05734 Version 4

Front Brake Noise and/or Front Brake Judder

Supersedes 16-002, dated April 27, 2016, to revise the information highlighted in **yellow**.

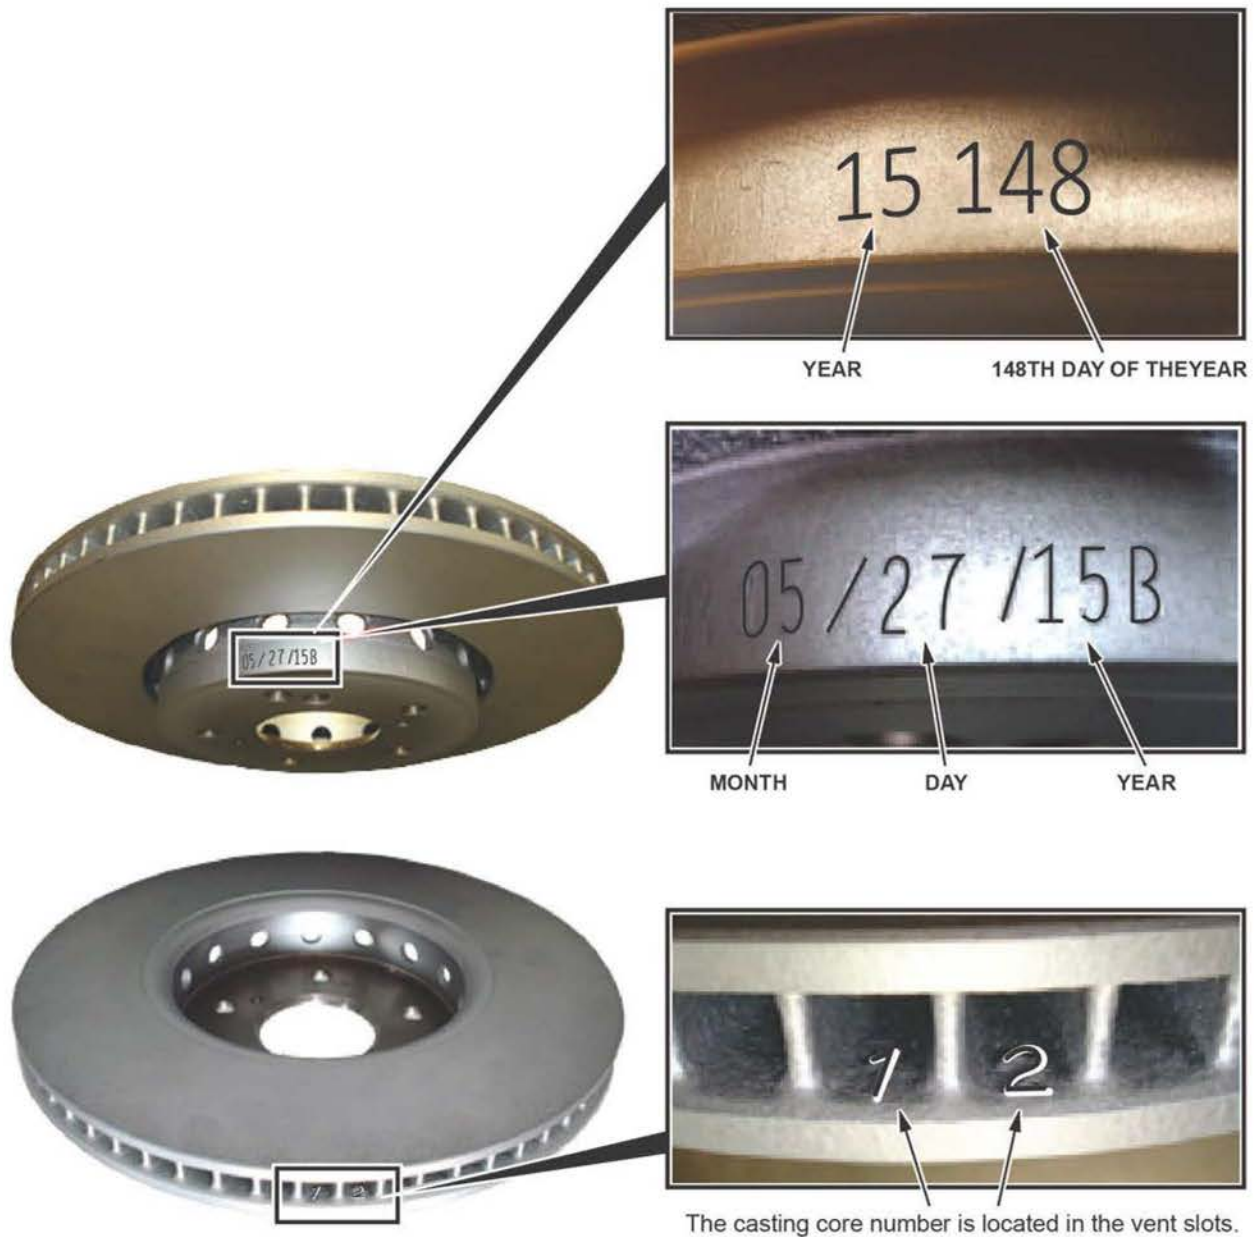
1. Inspect the supplier's manufacturing date code on new service brake discs to confirm they are from the newest mold. Wheel hub date stamping must be May 27, 2015, or later, by either conventional date format (MM/DD/YY) or Julian date format (YYDDD). The Julian date must be 15148 or later. The casting core number in the vent slots must be 11 or greater. If the new service parts do not meet these criteria, do not install them. Re-order a new set.

Julian date shows what number the day is of the year. May 27, 2015 is the 148th day of the year. As a Julian date, it will show as 15148.
